Renewable Natural Gas Request for Information

Responses to Questions Received

Friday, February 17, 2023 (*Updated Tuesday, February 21, 2023*)

PURPOSE: Provide responses to questions asked regarding the [Renewable Natural Gas \(RNG\) Request for Information \(RFI\)](#), issued by the Philadelphia Energy Authority (PEA) on behalf of the Philadelphia Water Department (PWD). Questions for this RFI were due on Friday, January 27th, 2023, and answers to these questions are due (to be posted on PEA's website) by February 20, 2023.

Figure 1: Schematic of NEWPCP Gas Treatment prior to the Cogeneration Facility

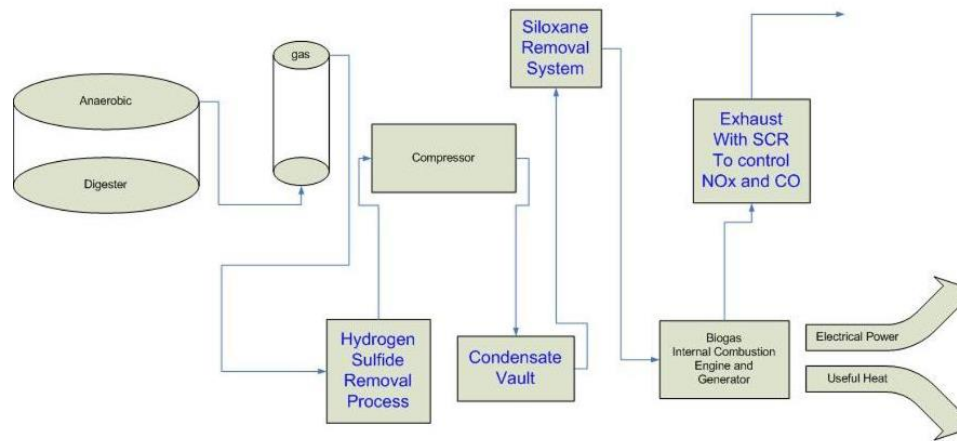
10. *What existing gas treatment exists ahead of the Cogeneration Plant and/or boilers/dryers? What biogas conditioning is performed prior to those listed uses?*

A: At SWWPCP, the only biogas conditioning that exists is the removal of moisture and particles via condensate and sediment traps (otherwise, there is no existing gas treatment ahead of the boilers and/or dryers). At the NEWPCP Cogeneration Facility, there exists a Hydrogen Sulfide Removal System prior to the compressor, and following the compressor exist a Condensate Vault and Siloxane Removal System (schematic shown in Figure 1 below).
